CRA Urban Design Overlay District- City Staff and Community Comments

CITY STAFF COMMENTS			
Commentator	Referenced Section	Comment	Response
Public Works	2.2-2.4	Is this document going to trump the LDC entirely?	No, the document will not trump the LDC entirely. Where a conflict exists between the Overlay and the underlying land development regulations, the Overlay will prevail. The Overlay will not alter allowable land uses under the current zoning, however, it will, in some instances modify dimensional standards and provide additional clarifying language related to the existing zoning. The Overlay's provisions will be limited to the Urban Core, Westside and Eastside Redevelopment Areas, excluding the City's existing Special Review Districts (SRD's) and the Port of Pensacola.
Public Works	Table 5.4.1.(D)	Tree cannot reduce required width for 5' wide pedestrian path.	Correct, trees cannot reduce the required width for a 5' wide pedestrian path. All ADA regulations must be adhered to. Table 5.4.1.(D) does not supersede ADA, not does any other section of this Overlay.

Figure 5.6.1: Awnings & Canopy Encroachments Illustrated

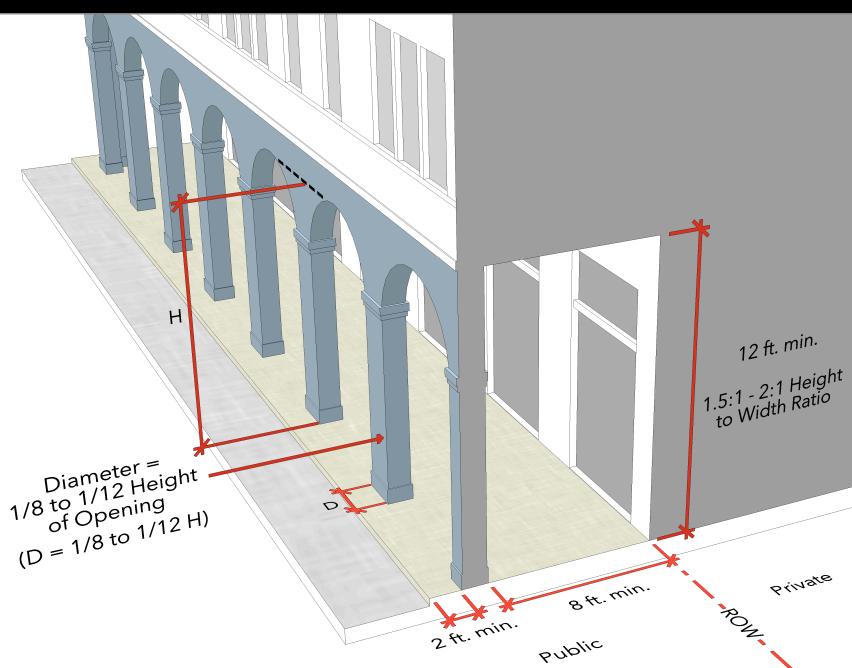
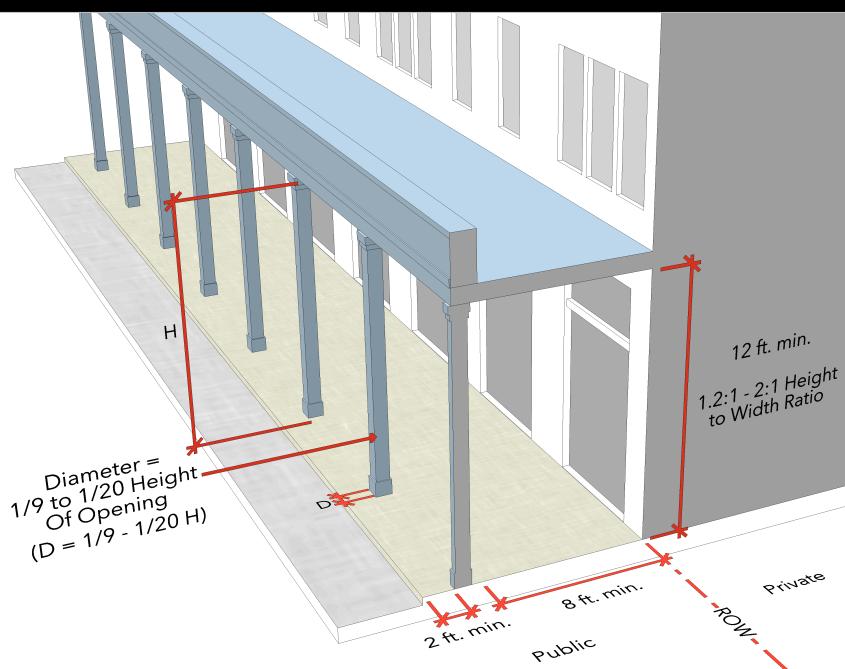
Public Works	Entirety of Section 5.6	No encroachment into the City right of way is allowed without a license to use (LTU). This entire section promotes/encourages the idea of encroachments.	Added language re: LTU for all encroachments.
Public Works	5.7 Intent	This is going to impede development.	Your Land Development Code and Comprehensive Plan encourage on-street parking already.
Public Works	5.7.1.d	So is this saying if no on-street parking is allowed they have to build a garage? Then in 5.7.3.ii they force them back into the lot?	If on-street parking is not allowed then parking will be placed behind the front facade or in the rear of the lot, however, a garage is not required.
Public Works	5.7.1.e.i	So who determines if the rear lane is possible?	Rear lane feasibility will be subject to the discretion of the developer.
Public Works	5.7.2.a	How is this even possible to enforce? Also in the ROW requires LTU.	Language included to coordinate with Public Works. As for enforcement, it is same as meeting parking requirements. Submissions will have to show how and where bicycle parking is provided.
